Comparison of existing and proposed Standard Plan 101C standards

Submitted by Jim Share
of DOT
at Board Hearing of 7/3/07
#17

STD. PLAN
101C

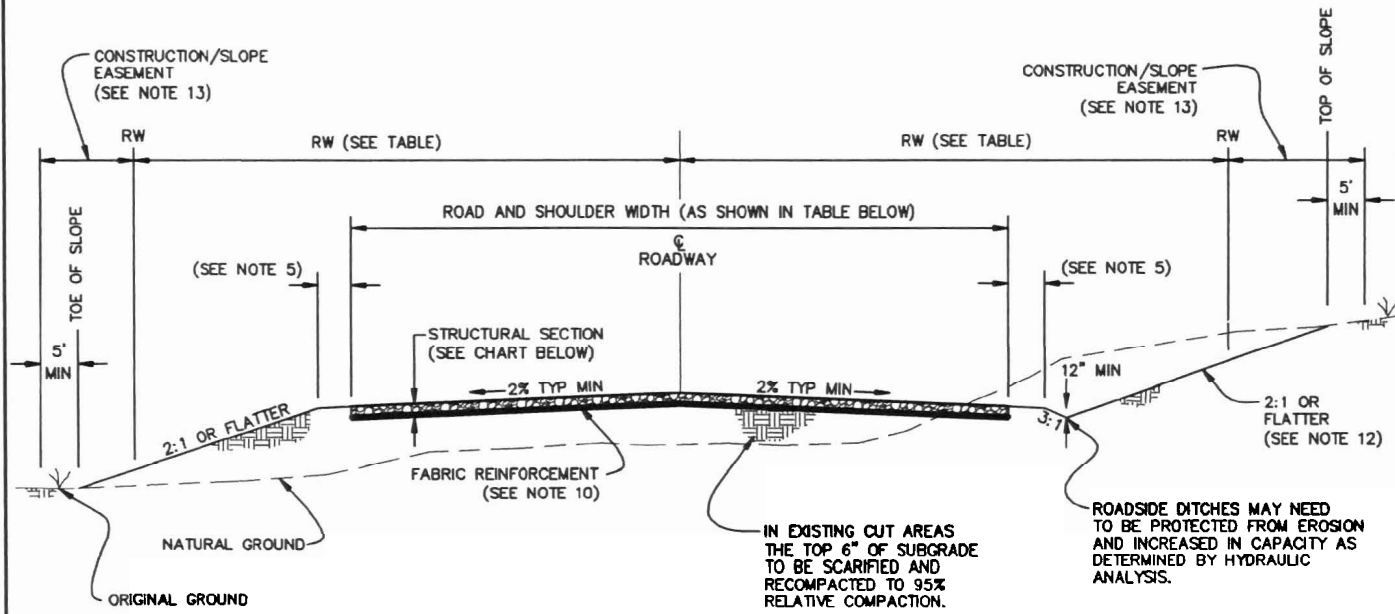
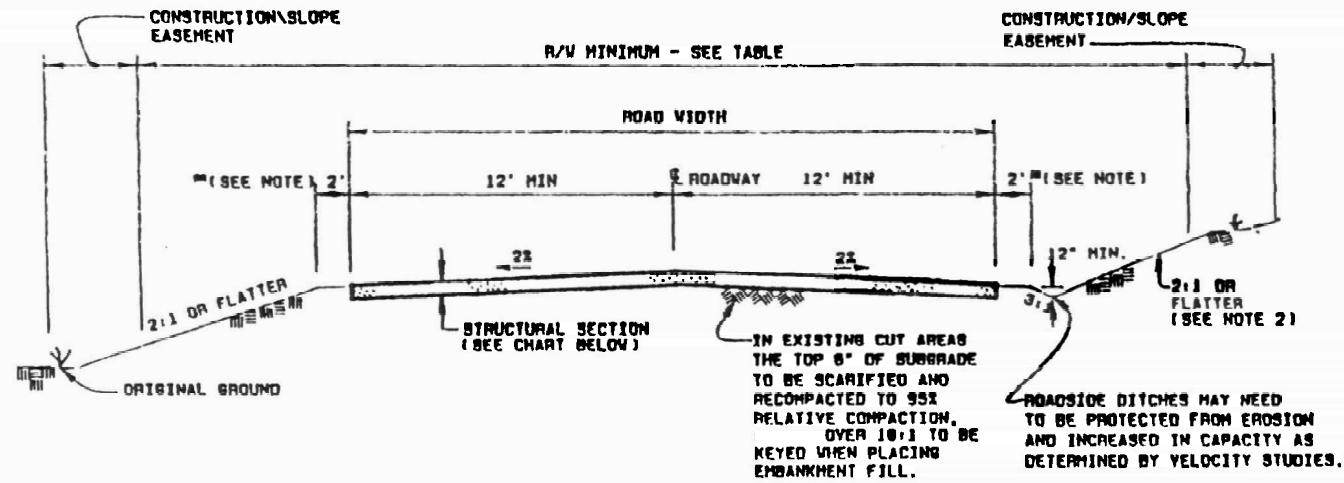
Existing Standard		Proposed Standard		
Width	Up to 5,000 ADT,	24' roadway, 2' shoulders each side	Up to 2,000 ADT	Roadway widths vary from 18' to 22', shoulders vary from 1' to 6', each side.
			Above 2,000 ADT	use Standard Plan 101A or 101B
Structural Section	Up to 3,000 ADT	Gravel	Up to 400 ADT	Aggregate Base
	3,001 to 5,000	Chip Seal over Aggregate Base	401 ADT and above	AC over Aggregate Base
	5,001 and above	AC over Aggregate Base	Fabric reinforcement for all ADTs if R Value is less than 10	
			Paved Surface if above 3,000 elevation	
Grades	12% Maximum Grade (Can go up to 18% with County Engineers Approval)		Up to 400 ADT	12% unpaved, 15% paved
			Above 401 ADT	13%
Design Speed (MPH)	Under 3,000 ADT	20	Under 150 ADT	20
	3,001 to 5,000	25	151 to 400	25
	5,001 to 7,000	30	401 to 2,000	40
	Above 7,000	35	Above 2,001	Use Standard Plan 101A or 101B

ADT	RW	ROADWAY WIDTH	SHOULDER WIDTH	DESIGN SPEED	MAX GRADE	STRUCTURAL SECTION
1-150	50'	18'	1' (EACH SIDE)	20 MPH	15% PAVED	8" AB (SEE NOTE 11)
151-400	50'	20'	2' (EACH SIDE)	25 MPH	12% UNPAVED	10" AB (SEE NOTE 11)
401-1500	60'	20'	5' (EACH SIDE)	40 MPH	13%	4" AC ON 7" AB
1501-2000	60'	22'	6' (EACH SIDE)	40 MPH	13%	4" AC ON 8" AB
GREATER THAN 2,000 ADT USE STANDARD PLAN 101A OR 101B
